Subject: Change Oder 005- Midway Branch Force Main Conflicts and other Scope Modifications

Change Order 005-Midway Branch Force Main Delays

Change Order No. 05
Corporate Dr Segments 4&5
Project No. G1124 &G1125

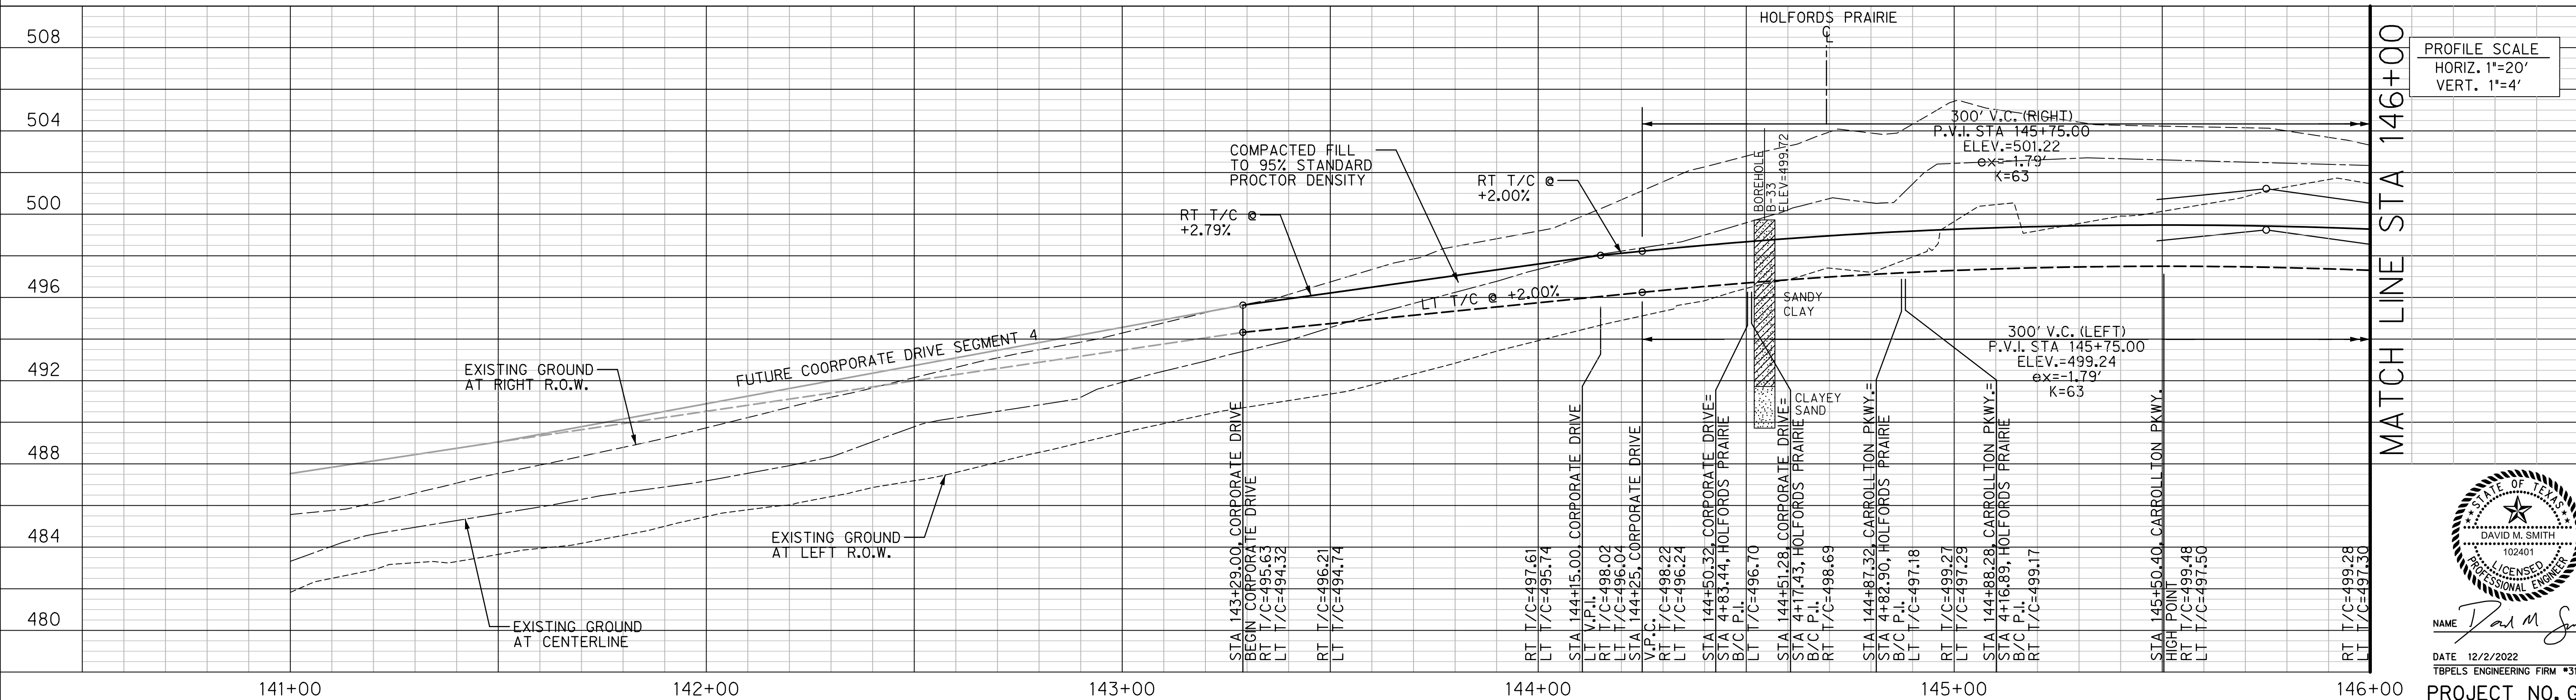
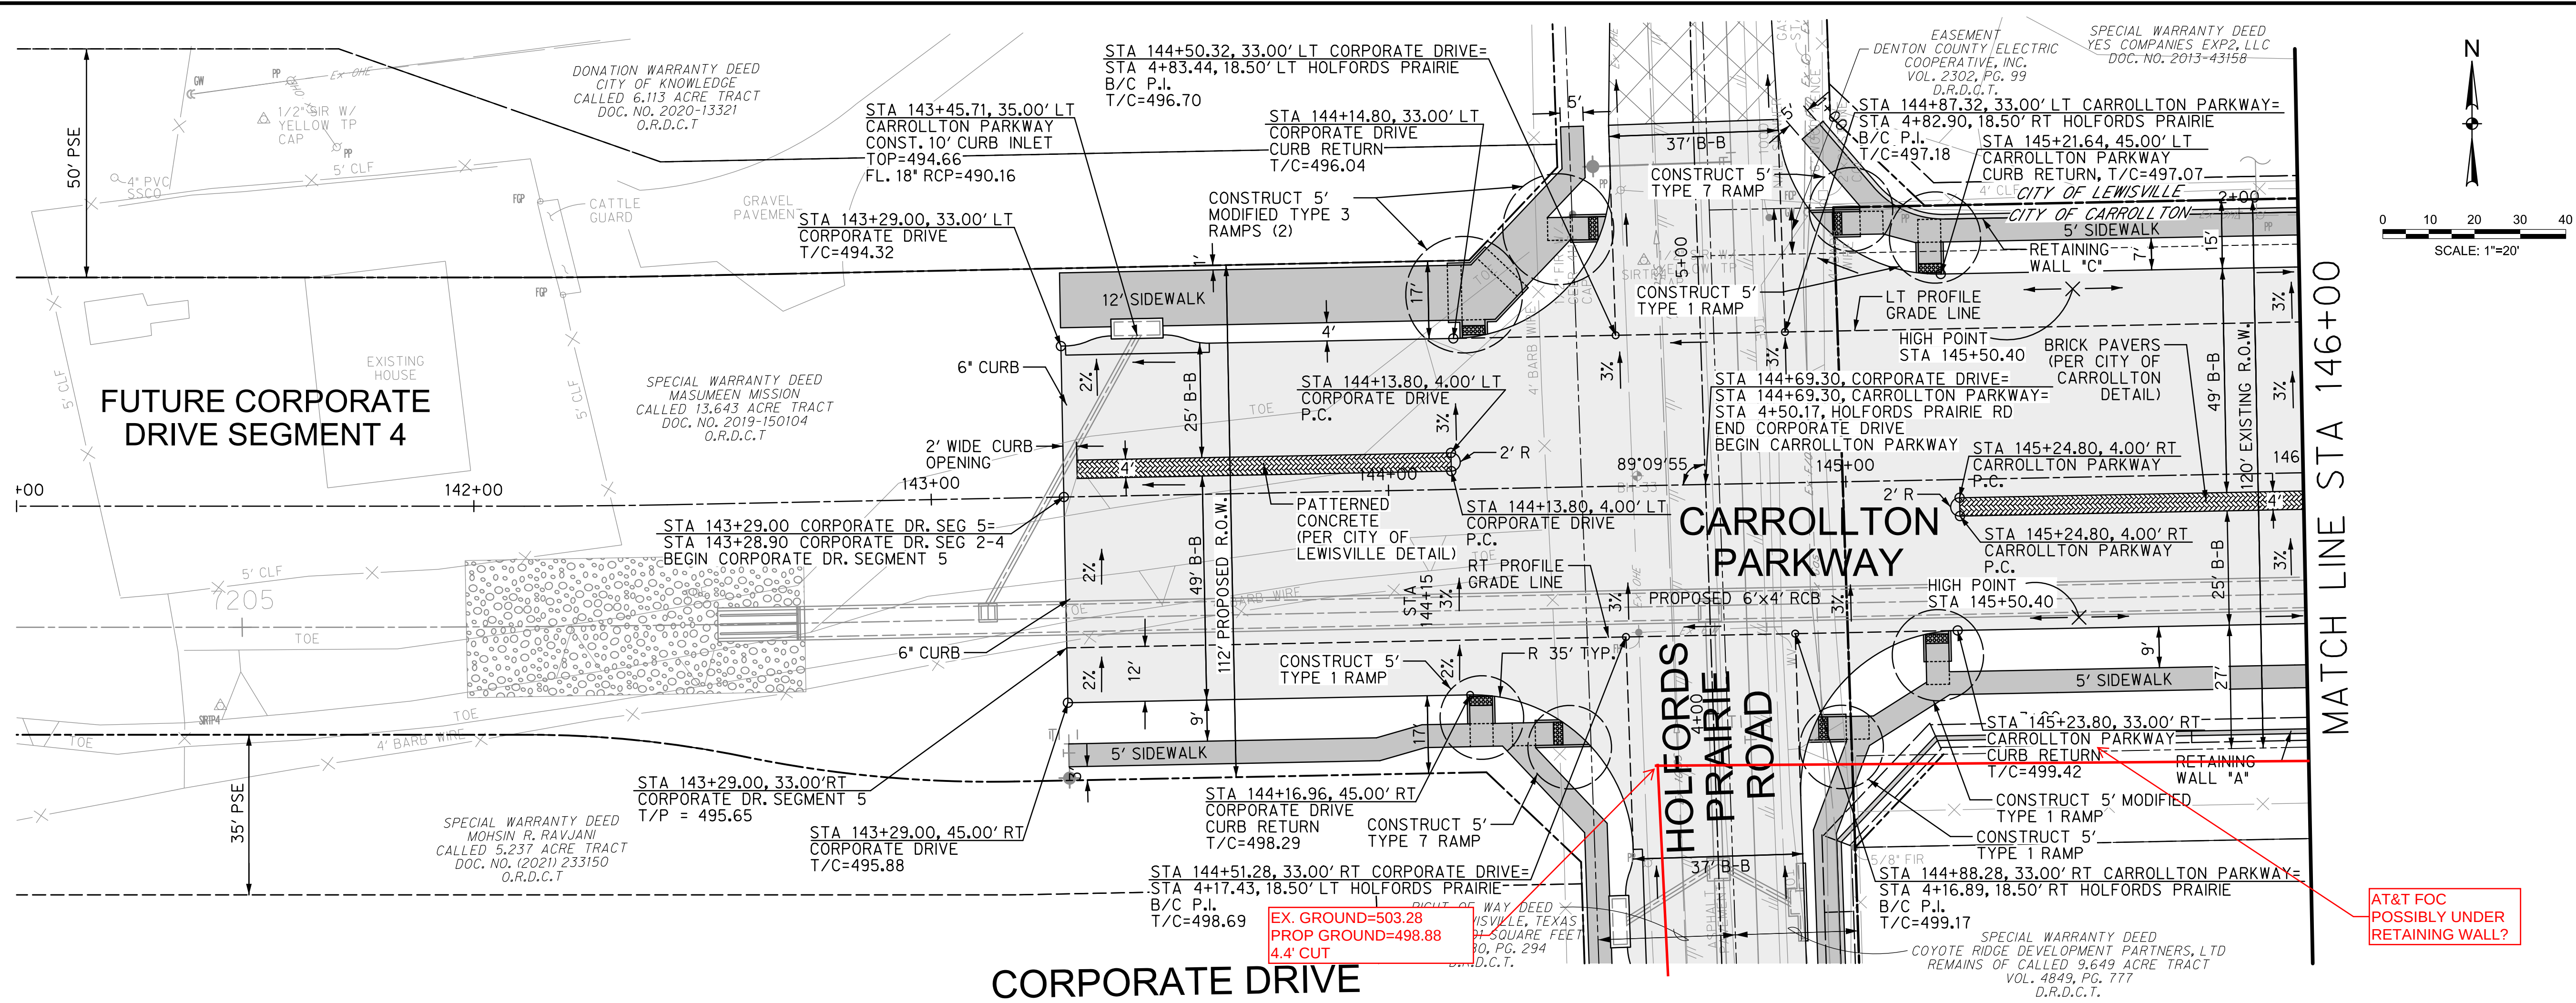
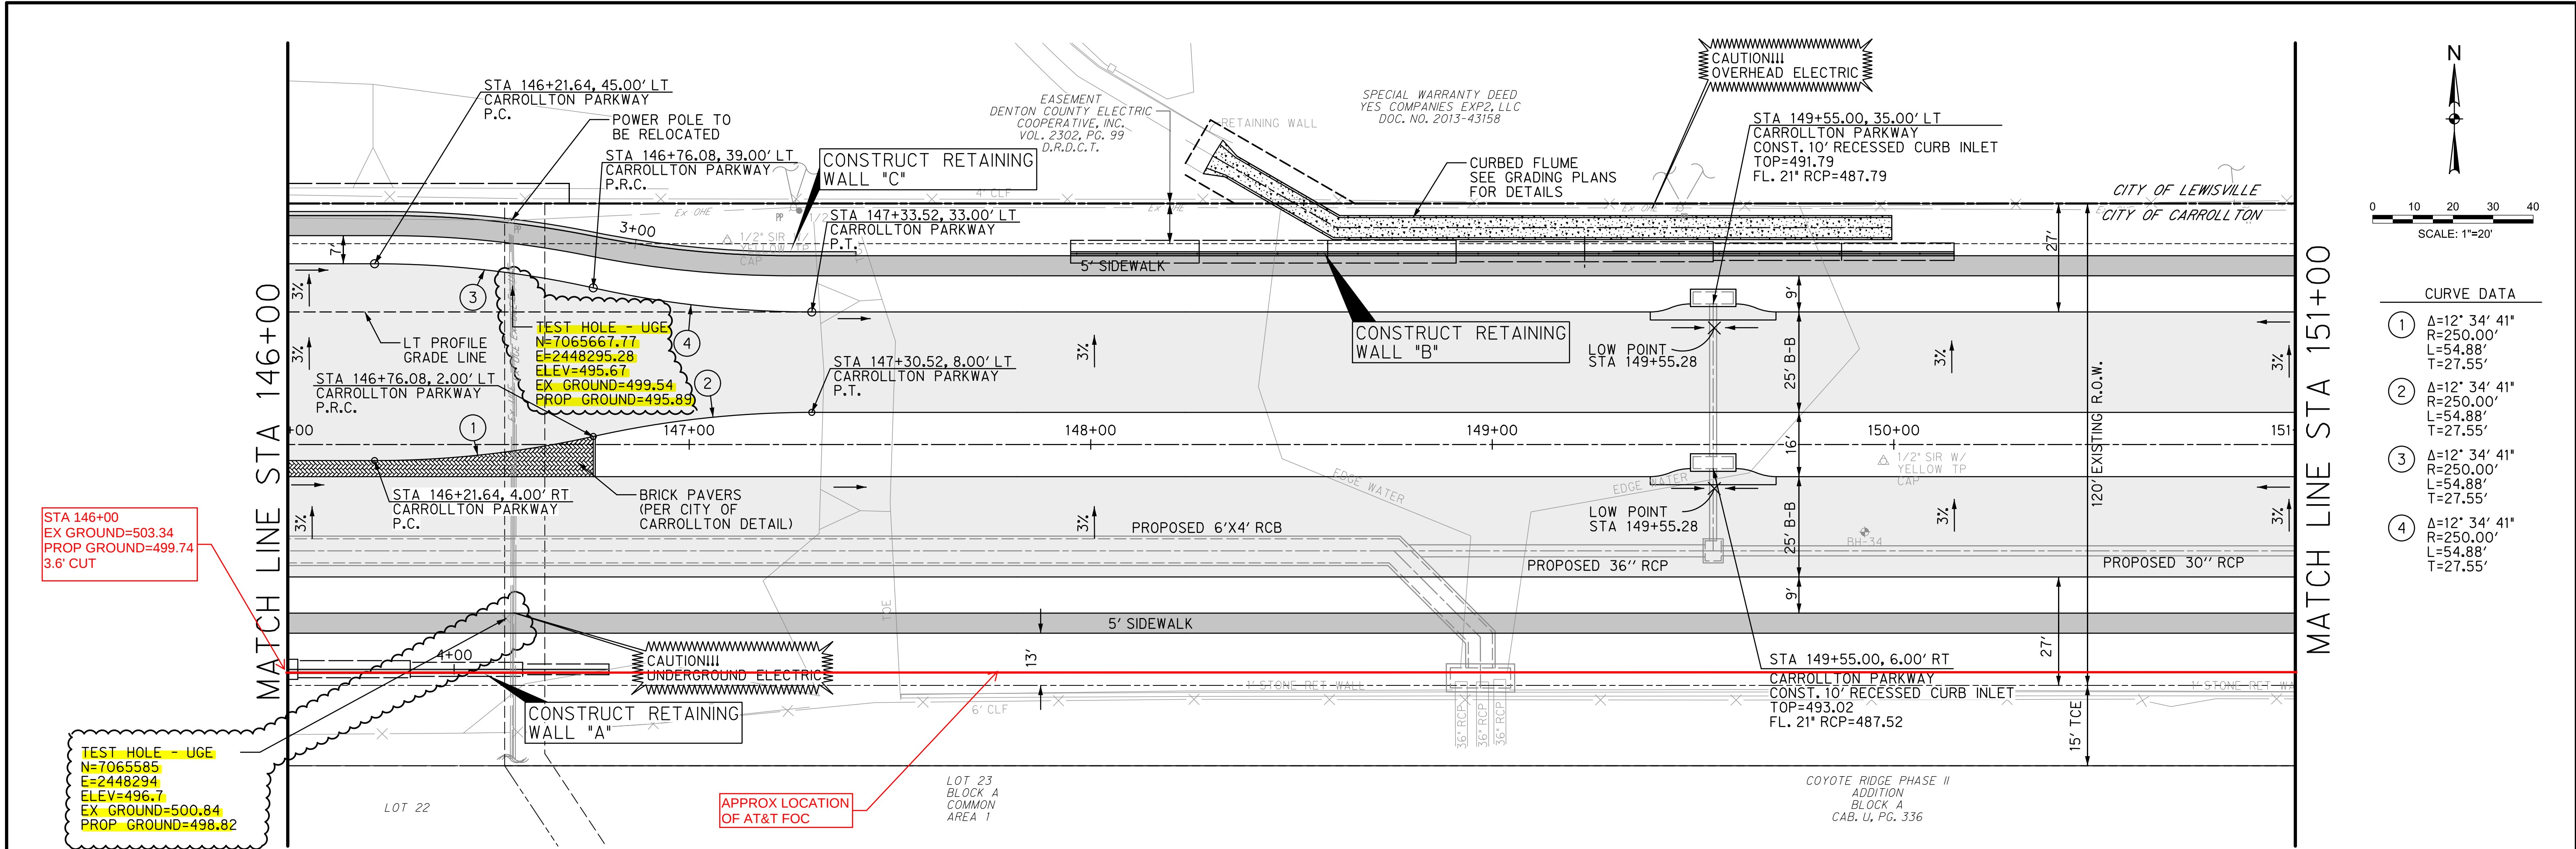
I tried to plot the AT&T info on the sheets as best I can. I included the pot hole information Jay provided along with cut information. The pot hole on AT&T is on the 3rd sheet. They will have no cover over the line once we are to proposed grade there. If they are only 30" deep per their plan (which matches the pot hole depth) then it looks like they may be in conflict pretty much the whole way. We are cutting pretty good over their line except between about 147+50 to 151+50. That might be the only area where they are not in conflict.

Here is what I got from AT&T. I am not sure how much of the line is in conflict with our improvements other than from Bunker Hill to where it crosses Holfords Prairie Road. How much of the stretch behind the HOA property needs to be relocated?
